UNITED STATES PATENT AND TRADEMARK OFFICE

APPLICATION NO.	FILING DATE	FIRST NAMED INVENTOR	ATTORNEY DOCKET NO.	CONFIRMATION NO.
09 661,433	09 13 2000	SABURO KAMIYA	107312	7860

# Office Action Summary

### DETAILED ACTION

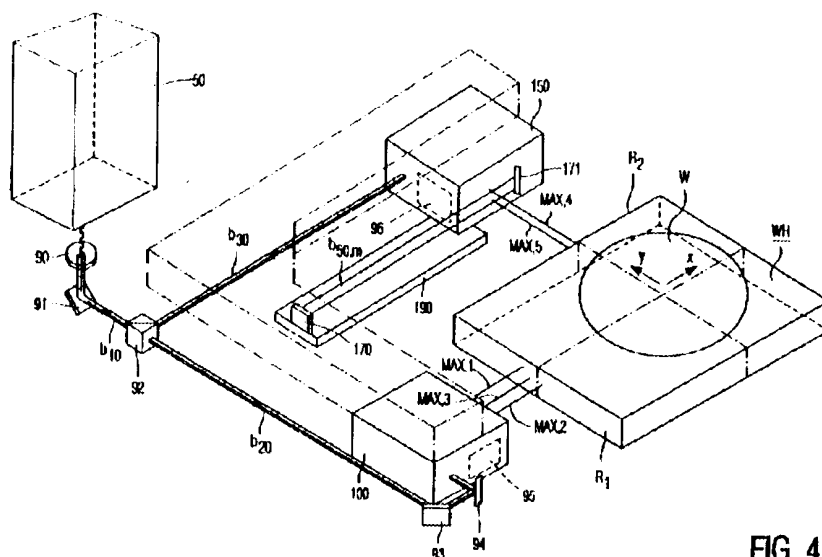
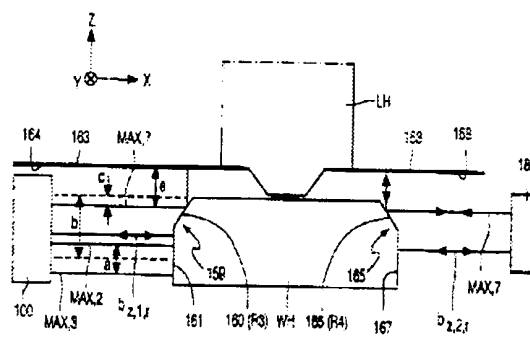
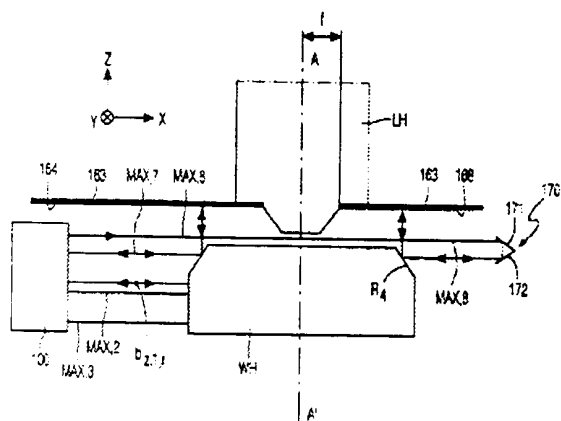
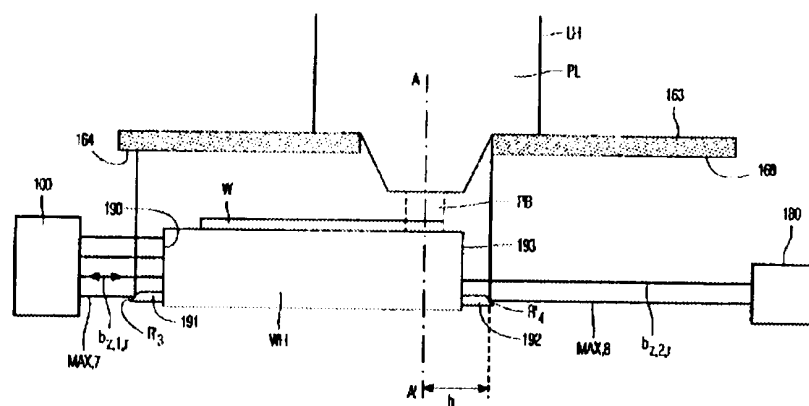
substrate in relation to the projection lens system. A second sensor system includes an X-Y interferometer system (figure 4) which includes reflecting a beam from the stage (WH) and an inclined reflective surface (159) on the stage and a reflector (163) mounted to the projection optical system such that a second beam is reflected by the inclined reflector (159) to the mirror (163). See figures 5-8. Not taught is the use of a separate reference plate reflector mounted on the substrate stage.
